## MEMORANDUM

TO: Advisory Board on Radiation and Worker Health, Work Group on Carborundum Company  
FROM: Robert Anigstein  
DATE: November 27, 2018  
SUBJECT: Audit of NIOSH Assessment of External Doses from Plutonium Fuel Pellets

**Figure 1. Glovebox Geometry Used in NIOSH MCNP Analysis (scales in cm)**

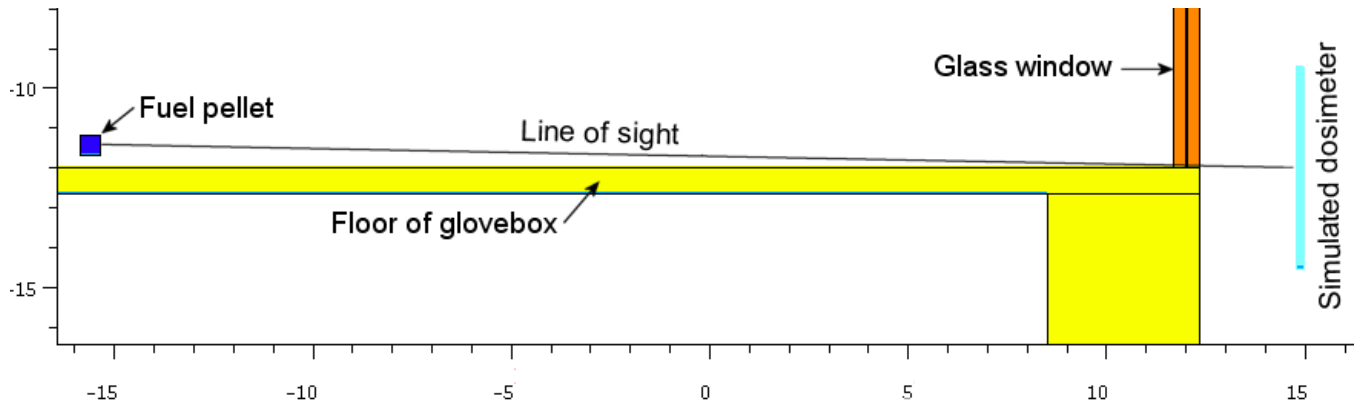
After the source bias was removed, the point detector (type 5) tallies at 1 ft and 1 m were 59% and 15% higher, respectively, than the corresponding type 4 tallies that were based on track lengths in simulated dosimeters. The cause was the exposure geometry, which is illustrated in Figure 1. As shown in the figure, the fuel pellet is only 1/8 inch above the floor of the glovebox. The simulated dosimeter, which measures 2 x 2 inches in the vertical plane and is 2 mm thick, is centered on the bottom surface of the glovebox. As shown by the line-of-sight drawn from the center of the fuel pellet to the dosimeter that just clears the edge of the glovebox floor, almost one-half of the dosimeter is effectively shielded from the source by the floor. In contrast, the point detector, which is located at the center of the dosimeter, is in full view of the pellet, except for the intervening glass window. The dosimeter at a distance of 1 m (not shown in the figure), is more exposed to the source, since the sloping line of sight would intercept it further below its

center. This helps explain the large discrepancy between the two tallies at 1 ft and the smaller discrepancy at 1 m.

**Finding 3. The simulated dosimeters in the glovebox geometry modeled by NIOSH are partially shielded by the floor of the glovebox, which reduces the calculated doses.**

We propose a change to the exposure geometry that would resolve this anomaly, as well as constituting a more realistic model of the gloveboxes used at Carborundum. Figure 2 shows some of the gloveboxes used in the plutonium research facility at Carborundum (Saulino et al. 1962a). As shown in the figure, each glovebox has two ports in which the worker inserts his hands. The plutonium would most likely have been positioned at the level of the center of the ports, perhaps halfway in between them. By scaling the elevation of the centers of the ports in the figure to the 3-ft average height of the glovebox (Saulino et al. 1962b), we estimate that the ports were 24 cm above the floor. We therefore revised the MCNP input file to place the center of the fuel pellet 24 cm above the glovebox floor, and placed both the point detectors and the centers of the simulated dosimeters at the same elevation. The resulting analysis of  $H^*(10)$  photon doses from  $^{241}\text{Am}$  showed that the results of the type 5 point detector tally at a distance of 1 ft from the pellet agreed with the results of the type 4 simulated dosimeter tally within 1.5%. This constitutes reasonable agreement, given the finite size of the dosimeter and the fact that the combined relative statistical uncertainty was 0.5%. The two tallies at 1 m agreed within 0.6%, while the combined relative statistical uncertainty was 1.4%. We thus believe that either type tally produces valid results if the fuel pellets are elevated well above the floor of the glovebox. The  $H^*(10)$  photon doses from  $^{241}\text{Am}$  based on type 4 tally results at distances of 1 ft and 1 m at the level of the glovebox floor are 45% and 21%, respectively, lower than the doses calculated at an elevation of 24 cm above the floor.
